**Addendum No. 1**

Contract No.: DA00331

*Replacement of Existing Pipes / Culverts in Hertford and Northampton Counties*

# INSTALLATION DETAIL

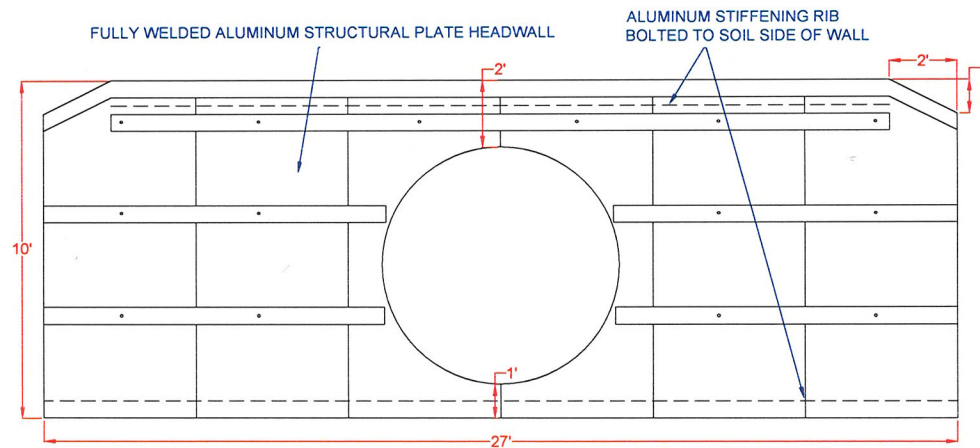
Plan Sheet "Installation Detail" the detail has been revised to clarify the foundation conditioning material and to illustrate the geotextile fabric requirements. Please void the existing Plan Sheet "Installation Detail" and replace with the revised Plan Sheet "Installation Detail".

SELECT MATERIAL CLASS VI FOR FOUNDATION CONDITIONING MATERIAL  
ENGINEERING FABRIC WILL BE INSTALLED BELOW THIS MATERIAL AS DIRECTED BY THE ENGINEER
